## **AIR ONE SUBDIVISION, RESUBDIVISION OF LOT 4 AND LOT 5**

APPLICATION NUMBER 3 DATE February 1, 2018  
APPLICANT Air One Subdivision, Resubdivision of Lot 4 and Lot 5  
REQUEST Subdivision

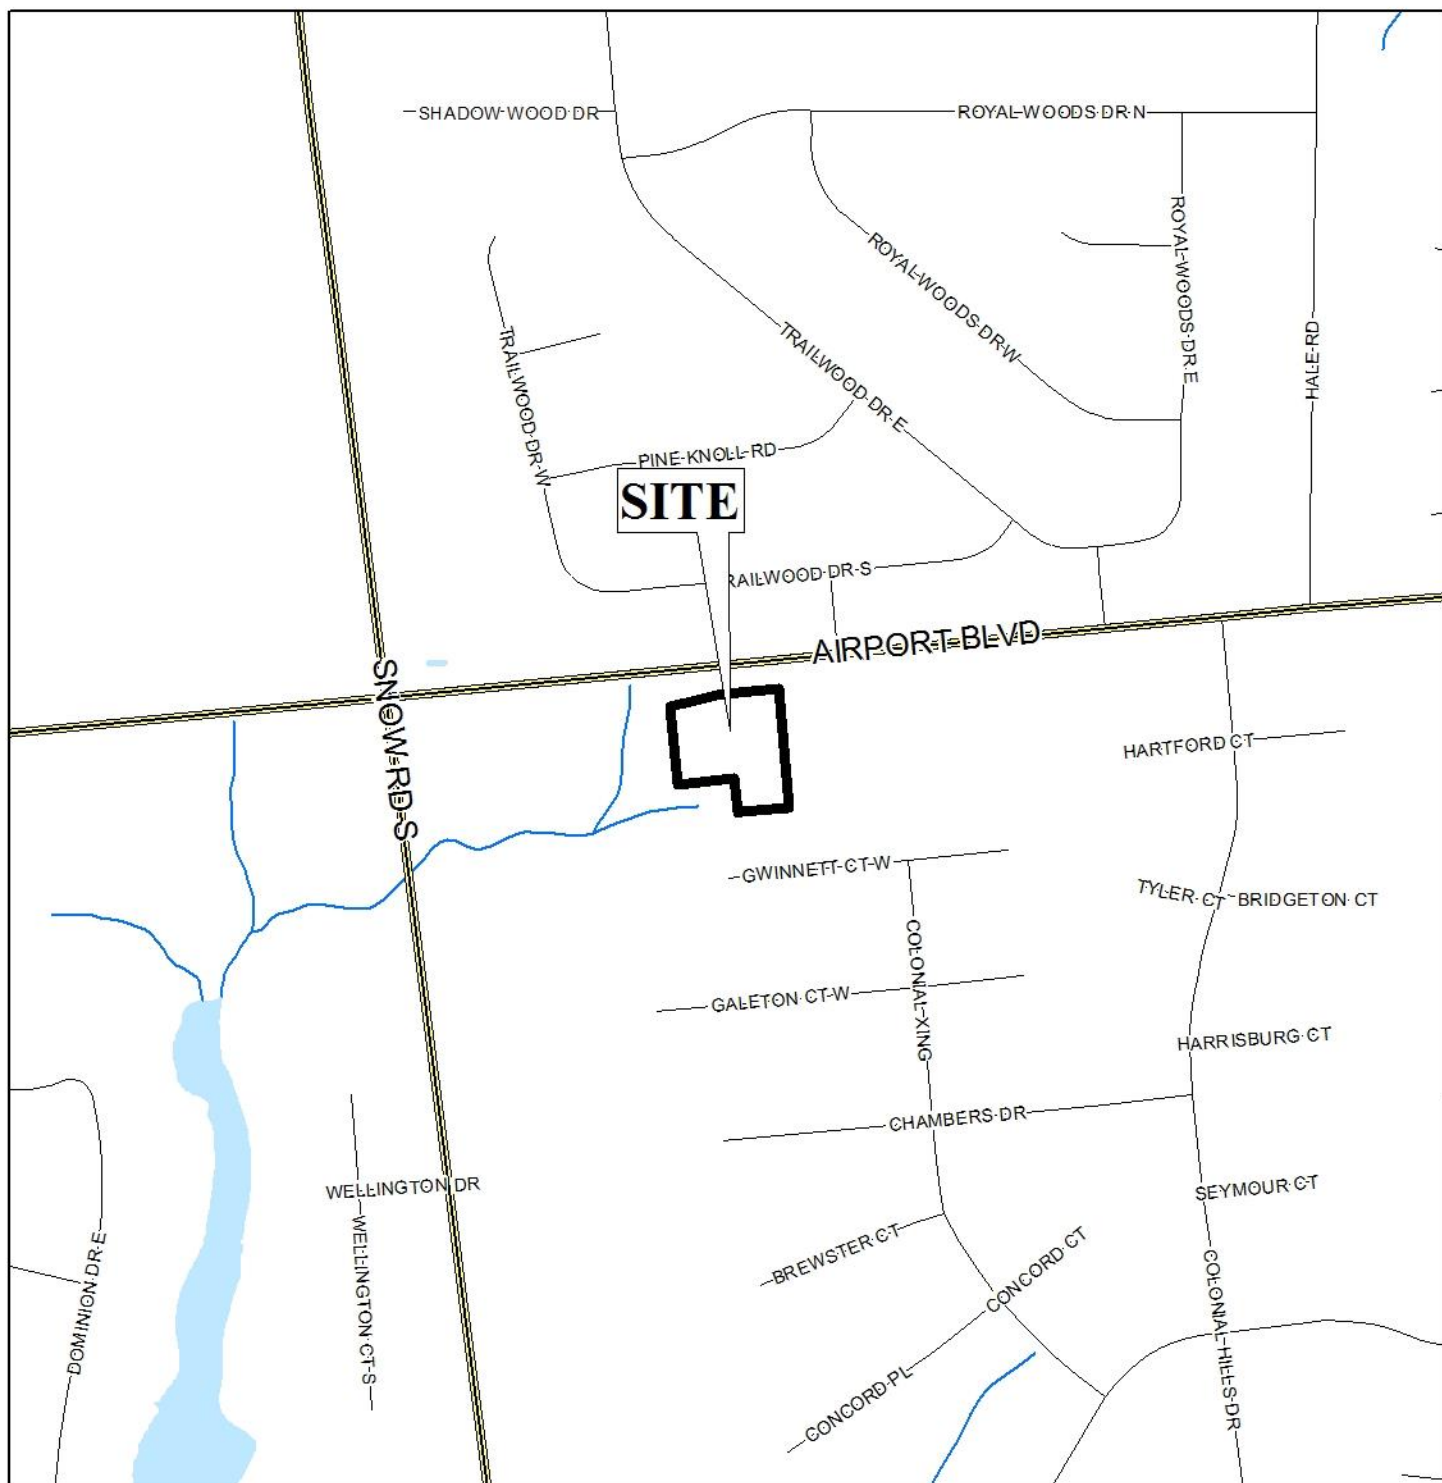
The proposed lots front Airport Boulevard, a major street on the Major Street Plan. As a major street, Airport Boulevard requires a 100' right-of-way width. The right-of-way width is depicted as "varies" on the preliminary plat. The distance from the centerline is illustrated and should be retained on the Final Plat, if approved.

The preliminary plat illustrates a 25' minimum building setback line along Airport Boulevard. If approved, the 25' minimum building setback along Airport Boulevard should be retained on the Final Plat. The preliminary plat also illustrates a 20' building setback to the rear to the rear of the proposed Lot 2. If approved, the 20' building setback should be retained on the Final Plat.

In accordance with Section V.D.2. of the Subdivision Regulations, the proposed lots each exceed the 15,000 square foot minimum lot size requirement for lots served by public water and individual septic systems. The lot size information for each lot is depicted in both square feet and in acres on the preliminary plat and should be retained on the Final Plat, if approved.

As a means of access management, a note should be placed on the Final Plat, if approved, stating that Lot 1 and Lot 2 are limited to one curb cut each to Airport Boulevard, with the size, design and location of the curb cut to be approved by Mobile County Engineering and conform to AASHTO standards.

It should be noted that there are easements present on the both the proposed Lot 1 and Lot 2. If approved, a note should be placed on the Final Plat stating that no structure shall be erected in any easement.

This site is located in the County; therefore, any lots which are developed commercially and adjoin residentially-developed property must provide a buffer, in compliance with Section V.A.8. of the Subdivision Regulations. A note should be placed on the Final Plat, if approved.

- 1) Retention of the minimum right-of-way widths to Airport Boulevard;
- 2) Retention of 25' minimum building setback line along Airport Boulevard;
- 3) Retention of 20' minimum building setback line along the rear of Lot 2;

- 4) Retention of the lot size information in both square and in acres on the Final Plat, adjusted for dedication;
- 5) Placement of a note on the Final Plat stating that Lot 1 and Lot 2 are limited to one curb cut each to Airport Boulevard, with the size, design and location of the curb-cut to be approved by Mobile County Engineering and conform to AASHTO standards;

- 6) Placement of a note on the Final Plat stating that any lots which are developed commercially and adjoin residentially developed property must provide a buffer, in compliance with Section V.A.8. of the Subdivision Regulations;

- 7) Placement of a note on the Final Plat stating that no structures shall be erected in any easement;
- 8) Compliance with Engineering Comments and placement as a note on the Final Plat: *(Must comply with the Mobile County Flood Damage Prevention Ordinance. Development shall be designed to comply with the storm water detention and drainage facility requirements of the City of Mobile storm water and flood control ordinances, and requiring submission of certification from a licensed engineer certifying that the design complies with the storm water detention and drainage facility requirements of the City of Mobile storm water and flood control ordinances prior to the issuance of any permits.); and*
